Amendments to the Drawings

Appl'n No.: 10/811,300
Title: Robust Piezoelectric Power Generation Module
Inventors: Alessandro Pizzochero et al.
Annotated Marked-Up Drawings

FIG. 1

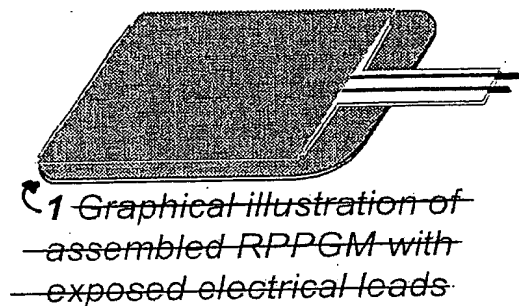
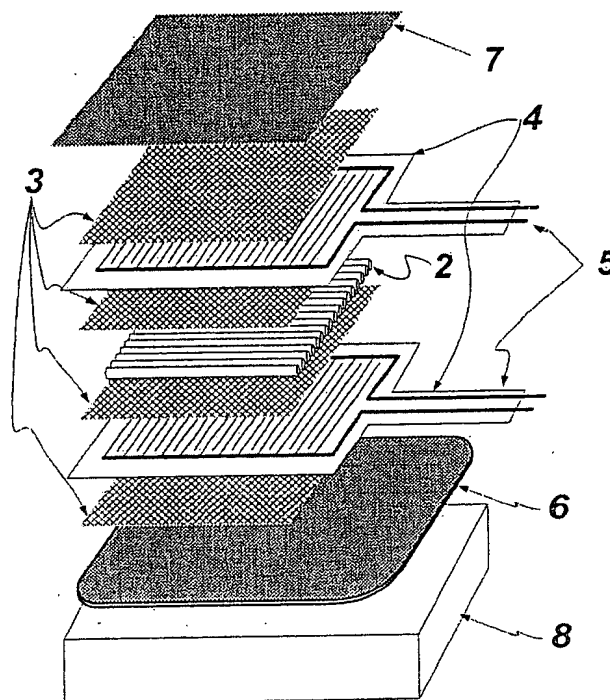
Fig. 1 is being amended to be labeled as Figs. 1A and 1B, and indicated by way of mark-ups in a legend on page 1/9 of the enclosed Annotated Marked-Up Drawings and as indicated in the enclosed Replacement drawings. Descriptor text is being deleted below Figs. 1A and 1B. The descriptions are being added by way of amendment to the specification on page 5, line 18. No new matter is being introduced by way of this amendment.

FIG. 1

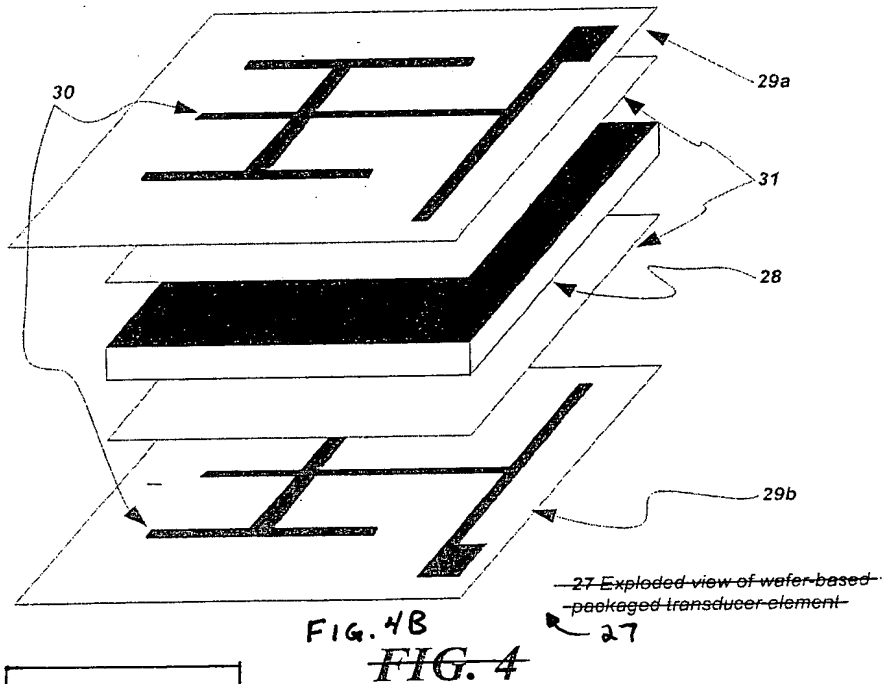
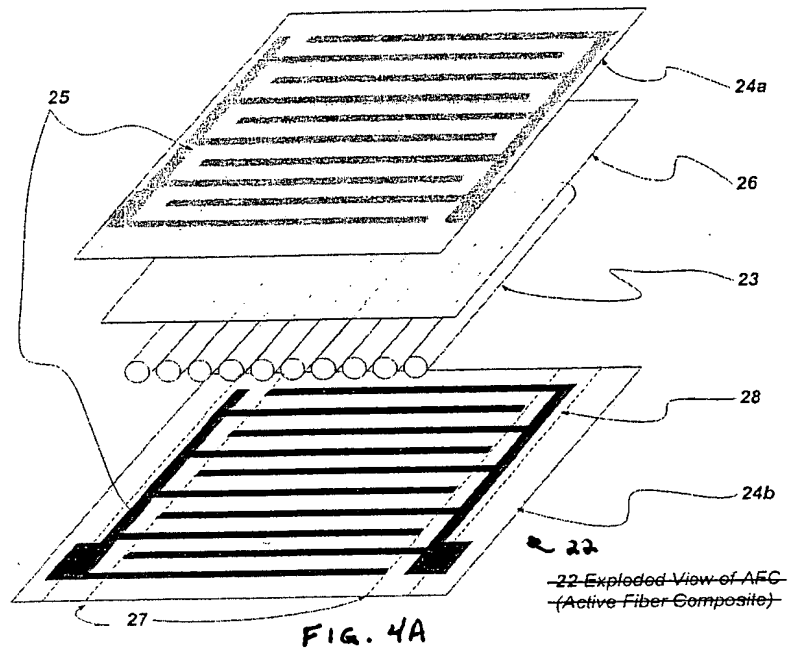
Fig. 4 is being amended to be labeled as Figs. 4A and 4B. A legend is being added to indicate same. Descriptive text in Fig. 4 is being deleted, but it is included in the specification as originally filed at page 8, line 17 in reference to Fig. 4.

FIG. 9

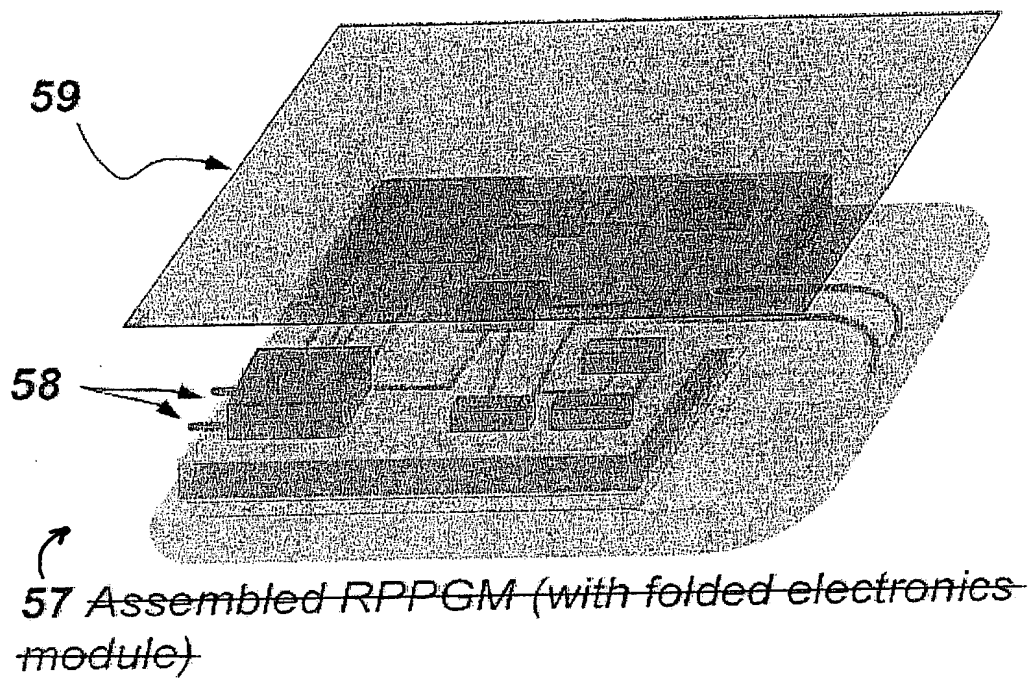
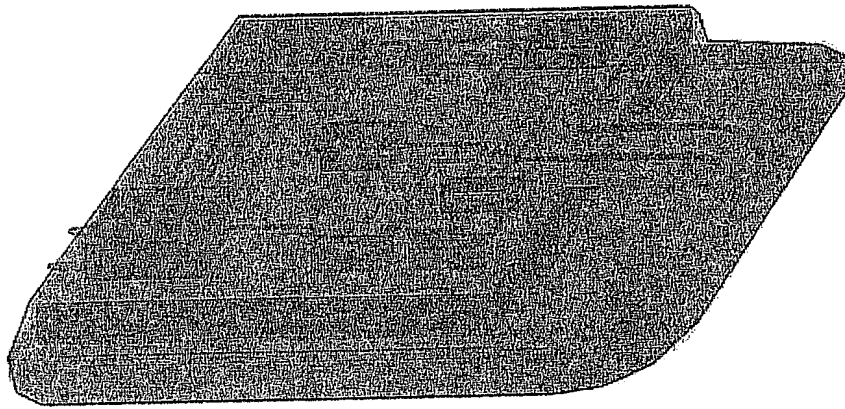
Fig. 9 is being amended to remove descriptor text that is included in the specification as originally filed in the Brief Description of the Drawings and page 17, lines 4-15.
